Access Compliance Report

Public Rights-of-Way

(Curb Ramps)

Intersection ID: 24153	Main Street: FRESHWELL_RD	Cross Street: STEPHENDALE_DR	Location: E
ADA ID: F744F0090E5E	Ramp Type: BlendTrans2	Initial Pass/Fail: Fail	Overall Compliance: No
Severity Score: 8.75			
Codes/Mitigation Info/Possible Solution		Field Measurements/Component Compliance

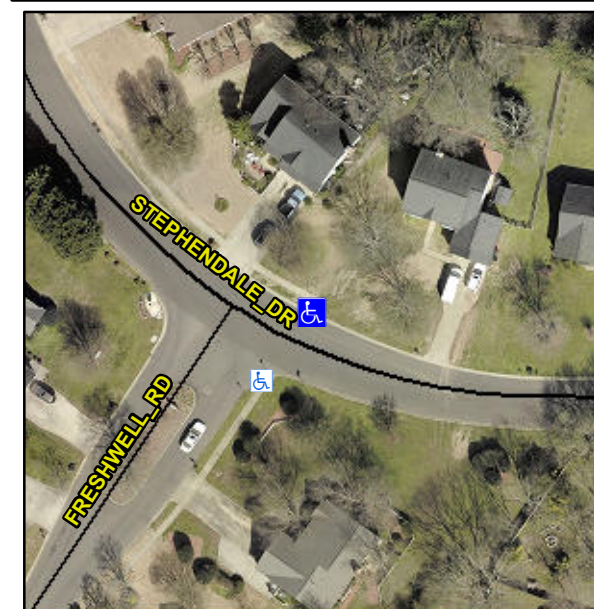
Not Found, R304.5.1

Compliance	Description	Data	Compliance	Description	Data
N/A	Ramp Length (in)	95.0	Yes	BlendTrans Slope (%)	1.3
No	Ramp Width (in)	46.5	Yes	BlendTrans XSlope (%)	0.3
N/A	Flare Type LT	N/A	N/A	Flare Type RT	N/A
N/A	Flare Slope LT (%)	N/A	N/A	Flare Slope RT (%)	N/A
N/A	Flare Traversable LT?	N/A	N/A	Flare Traversable RT?	N/A
N/A	Landing Length (in)	N/A	N/A	DWS Provided?	N/A
N/A	Landing Width (in)	N/A	N/A	DWS Contrast?	N/A
N/A	Landing Slope (%)	N/A	N/A	DWS Length (in)	N/A
N/A	Landing X Slope (%)	N/A	N/A	DWS Full Width?	N/A
N/A	Landing Curb? (Y/N)	N/A	N/A	DWS Offset (in)	N/A
N/A	Shared Landing?	N/A			
N/A	Gutter Ponding?	N/A	N/A	Gutter Slope (%)	N/A
N/A	Gutter Lip Ht (in)	N/A	N/A	Gutter X Slope (%)	N/A
N/A	Painted X Walk1?	No	N/A	Painted X Walk2?	N/A
	X Walk 1 Direction	To SW		X Walk 2 Direction	N/A
	X Walk 1 Width (in)	N/A		X Walk 2 Width (in)	N/A
	X Walk 1 Slope (%)	6.4		X Walk 2 Slope (%)	N/A
	X Walk 1 X Slope (%)	0.5		X Walk 2 X Slope (%)	N/A

N/A	Ramp inside XWalk1?	N/A	N/A	Ramp inside XWalk2?	N/A
	Road Slope (%)	0.5		Clear Space?	N/A
	Road X Slope (%)	6.4	N/A	Clear Space to XWalk (in)	N/A
N/A	Any Obstructions?	N/A	N/A	Storm Grate/Utility Hazard?	N/A
	Obstruction Type			Storm Grate/Utility Type	
		N/A			N/A
			Yes	Surface Condition? (G/P)	Good
			No	Curb Slope (%)	35.9

Remove & Replace Curb Ramp With Two New Directional Ramps or Equivalent.
